# COMMUNITY MASTER PLAN

LEVEL B PLAN: AS APPROVED BY DEVELOPMENT REVIEW BOARD FEBRUARY 2008

PROPOSED AMENDMENT NOVEMBER 2022

Mesa del Sol

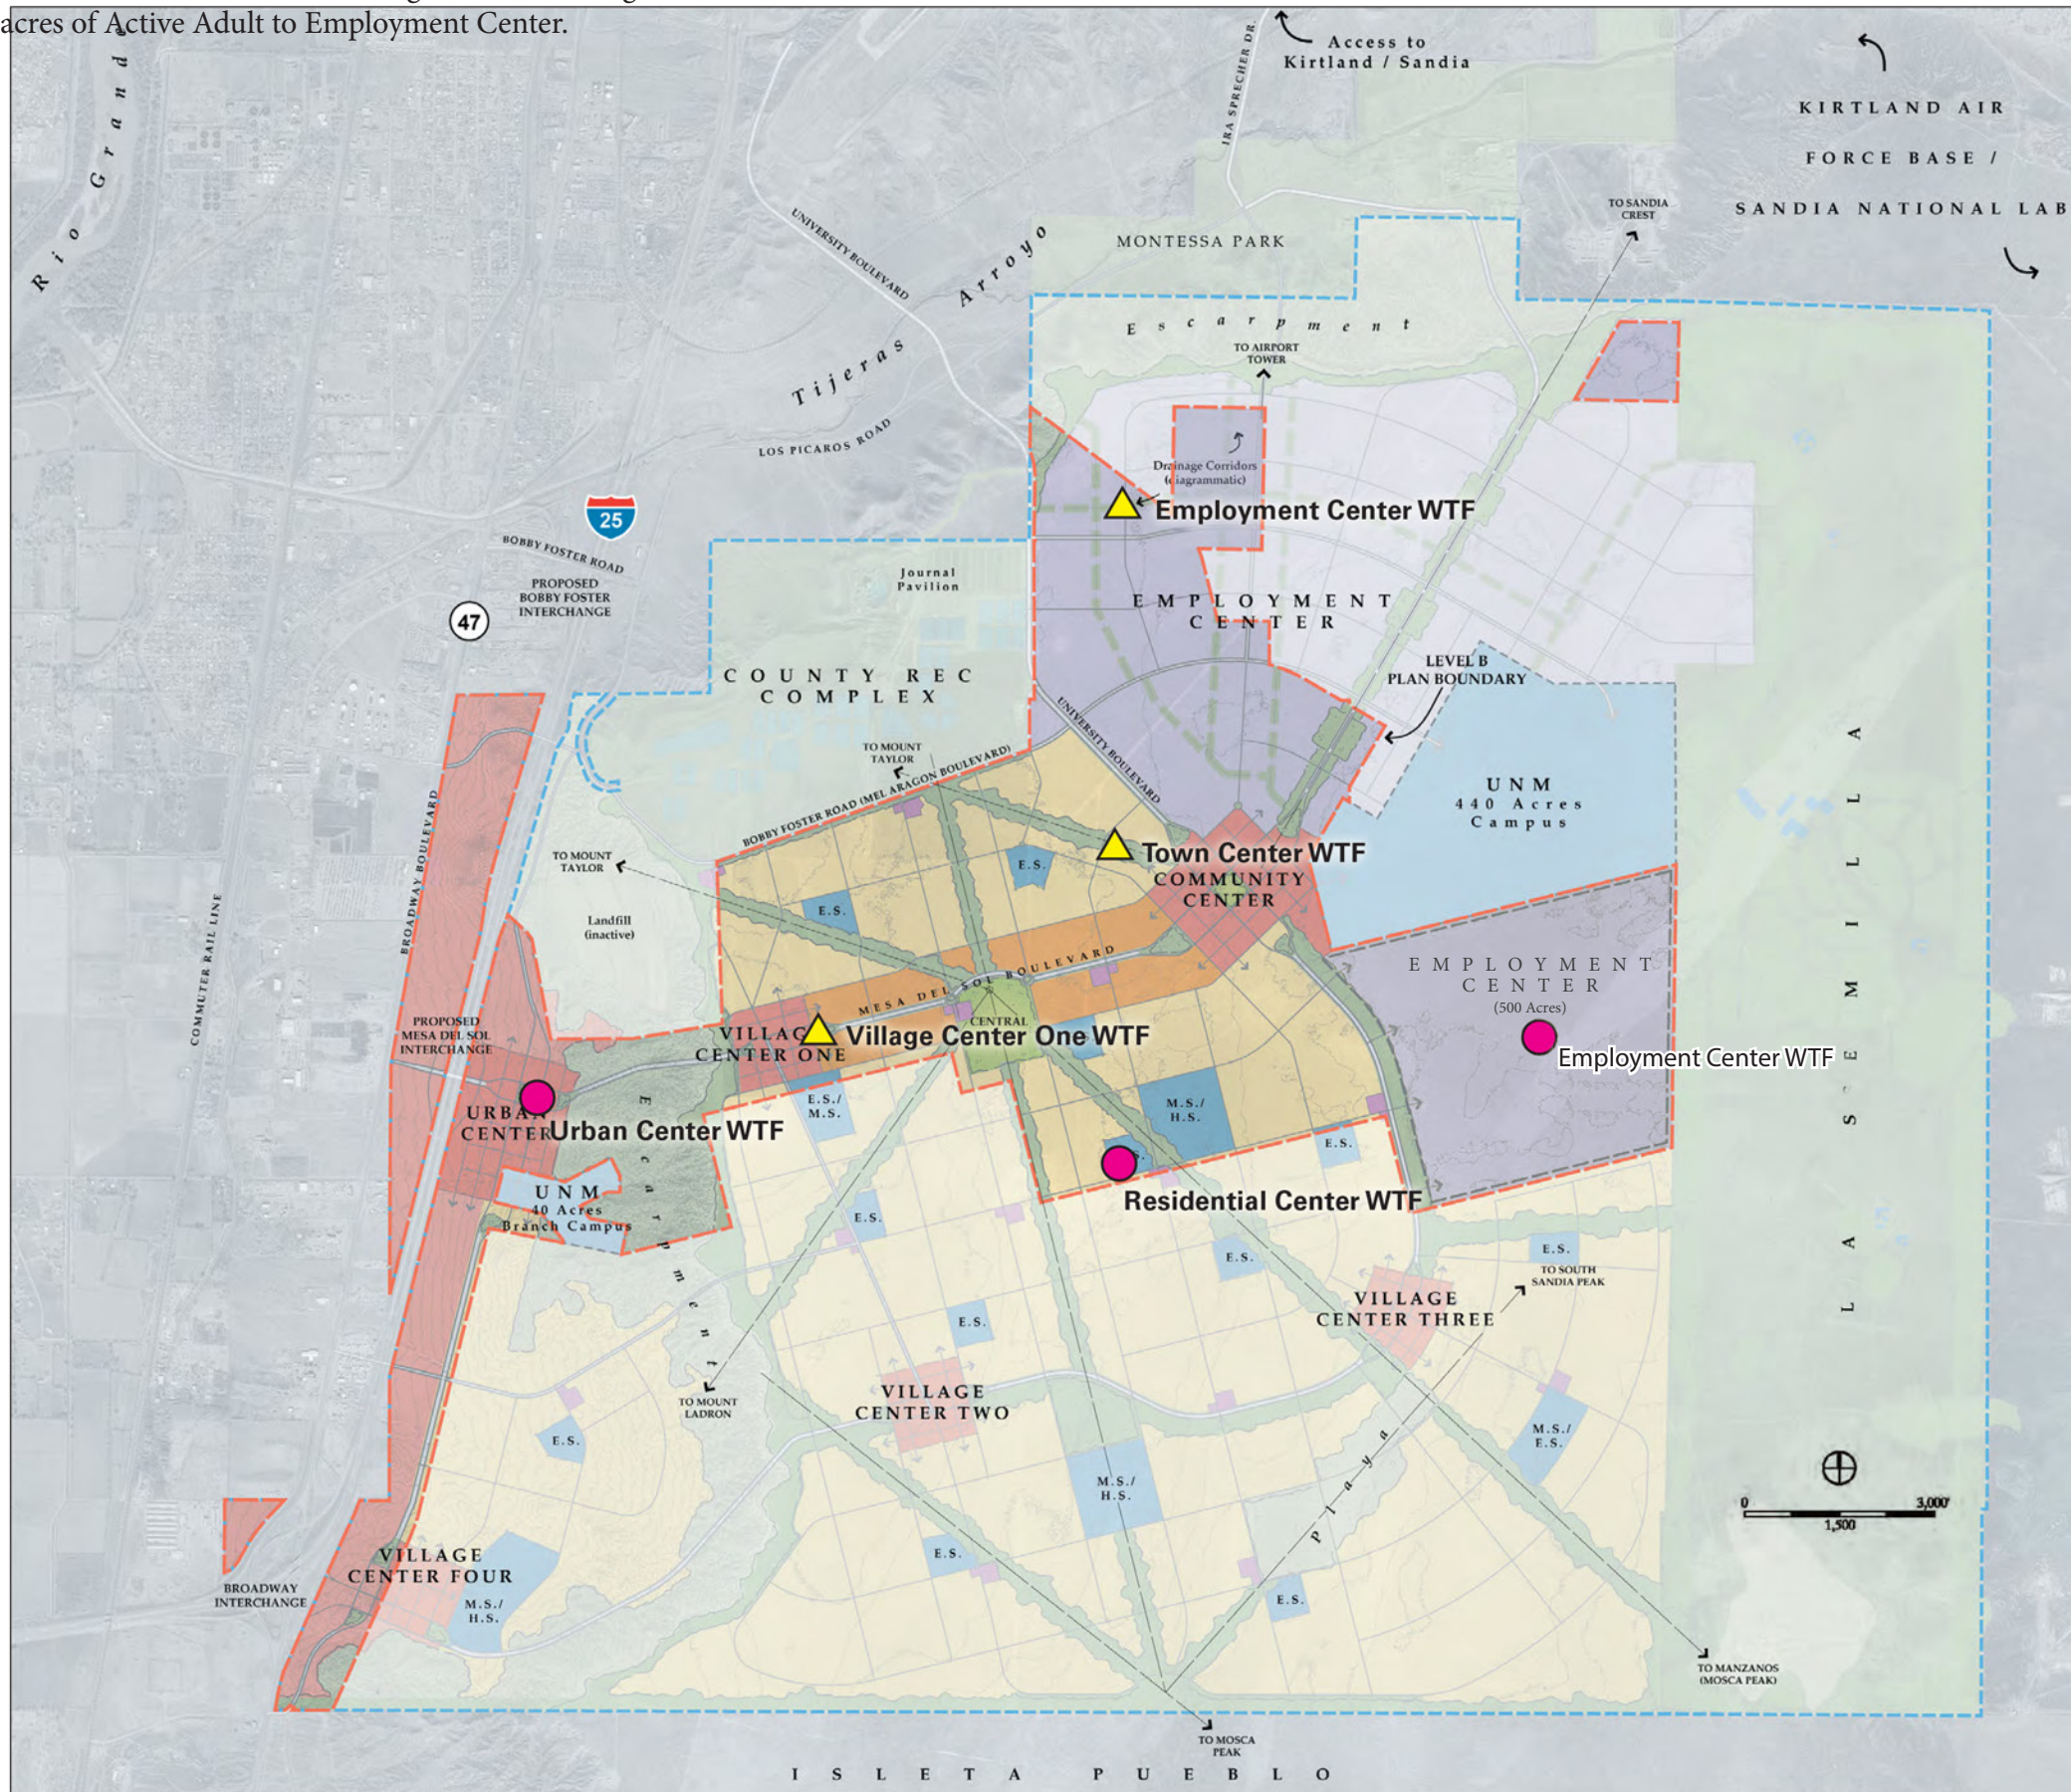
NOTE: Technical Appendices pages 39, 40, 41, 96, 106, and 127 were updated to reflect revised Level B Plan.

NOTE: Revised November 2022. Changed land use designation of 500 acres of Active Adult to Employment Center.
